ECN/PCN No.: M1711

Product Description: HIGH CAPACITANCE SUPERCAPACITORS	Abracon Part Number / Part Series: ADCS-E02R7S	<input type="checkbox"/> Documentation only <input checked="" type="checkbox"/> Series <input checked="" type="checkbox"/> ECN <input type="checkbox"/> Part Number(s) <input type="checkbox"/> EOL
Affected Revision: IR	New Revision: A	Application: <input type="checkbox"/> Safety <input checked="" type="checkbox"/> Non-Safety

After Change:

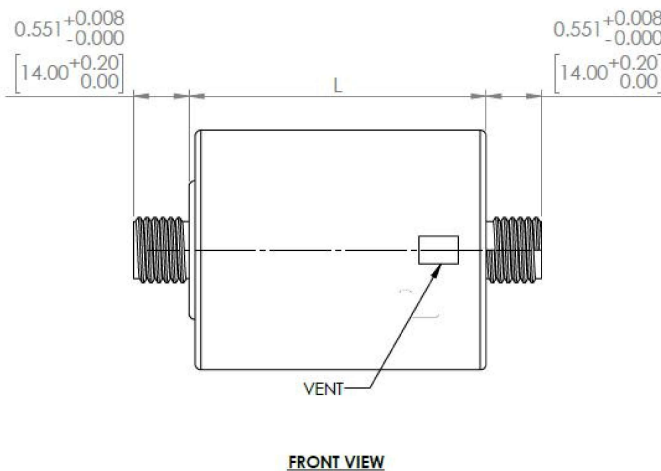
PART NUMBER	∅D±0.5	L±0.5
ADCS-E02R7SA128	2.387[60.5]	2.952[75]
ADCS-E02R7SA158	2.387[60.5]	3.346[85]
ADCS-E02R7SA208	2.387[60.5]	4.133[105]
ADCS-E02R7SA308	2.387[60.5]	5.433[138]

Cause/Reason for Change: Updating mechanical specs to include a new longer M16 stud/screw.		
Change Plan		
Effective Date: 3/26/2026	Additional Remarks:	
Change Declaration: Mechanical changes may affect product fit. These changes do not affect the products performance.		
Issued Date: 3/26/2026	Issued By: <i>Gerald Capwell</i>	Issued Department: Engineering
Approval: <i>Gerald Capwell</i> Director, Engineering	Approval: <i>Reuben Quintanilla</i> Quality Director	Approval: <i>Ying Huang</i> Purchasing Director
For Abracon EOL only		
Last Time Buy (if applicable):	Alternate Part Number / Part Series:	
Additional Approval:	Additional Approval:	Additional Approval:
Customer Approval (If Applicable)		
Qualification Status: <input type="checkbox"/> Approved <input type="checkbox"/> Not accepted <i>Note: It is considered approved if there is no feedback from the customer 1 month after ECN/PCN is released.</i>
